## Determination 2017/063

# Whether a barrier is required for a retaining wall to a residential property at 47 Carlingford Rise, Dinsdale, Hamilton

**Figure 1: Outline of site (not to scale)**

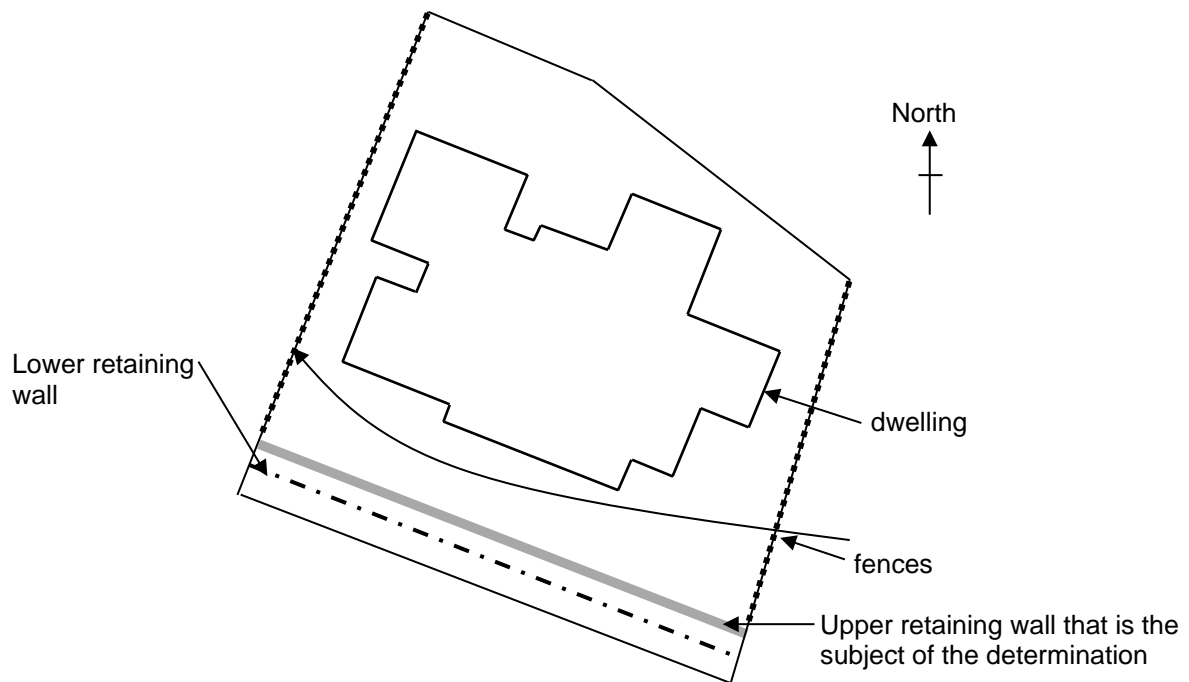
4.3.3 I note that the lower retaining wall, although not the subject of this determination, has a fall that is 1m or more and would normally require a barrier. However, in this instance once barrier to the upper retaining wall is in place a barrier to the lower wall will not be required because this area will then be inaccessible; the fencing extends to the edge of the retaining wall and there is no other access to the space (see Figure 1).

**Figure 2: Diagram of timber retaining wall (not to scale)**

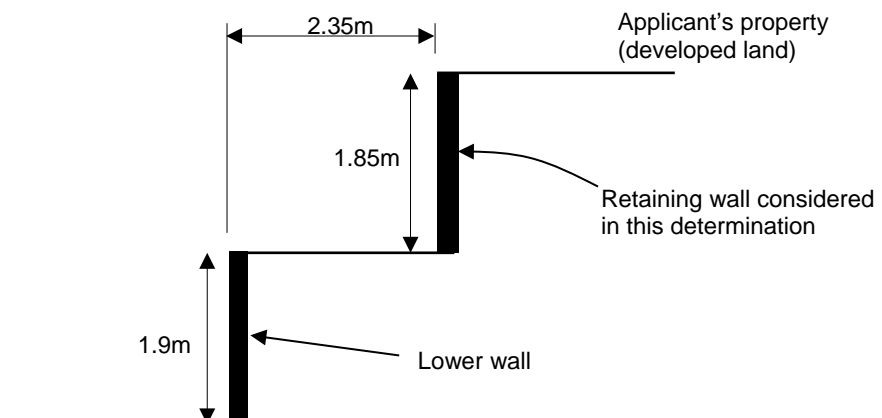
- the upper wall has a height of 1.85m (the proposed notice to fix relates to this wall), and there is a level area below this wall that is 2.35m wide
- the lower wall has a height of 1.9m

- 4.2.3 I must first consider whether a barrier is required to the retaining wall. Clause F4.3.1 states that a barrier is required where there is a sudden change of level within or associated with a building. The upper retaining wall has a fall of well in excess of 1 metre and runs along the edge of a lawn area at the rear of the house. The lawn is an area that is closely associated with the house, and, in the normal course of events it is expected to be used by the occupants of the house and by people visiting the property. A barrier is therefore required to reduce the likelihood of an accidental fall from the upper retaining wall.

- 4.2.5 Accordingly I conclude that a barrier is required to the retaining wall to reduce the likelihood of accidental fall, and the barrier needs to restrict the passage of children younger than six years of age.

- 5.1 In accordance with section 188 of the Building Act 2004, I hereby determine that the upper retaining wall requires a barrier to comply with Clause F4 and the authority was correct to propose to issue a notice to fix to the owner in respect of the noncompliance with Clause F4.
